Plating material of the contact pins has been changed from tin to silver.

Product Change Notification					PCN MCS - Material change		
owner	creation date	release date	released by	change order no	rev	page	D10-062-773
ghezziisa	07.03.2022	10.03.2022	riedlan	2023640	B	1 of 2

Current product appearance	New product appearance
Tin (Sn)	Silver (Ag)

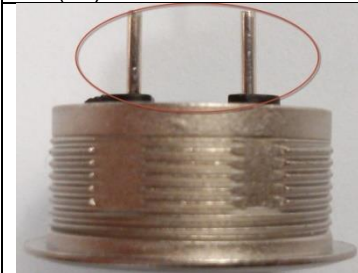
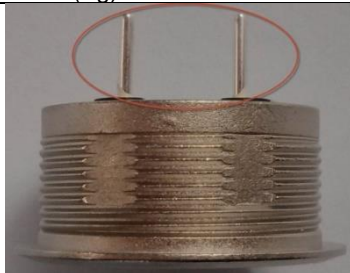
- Change of surface plating material on pins from tin to silver.
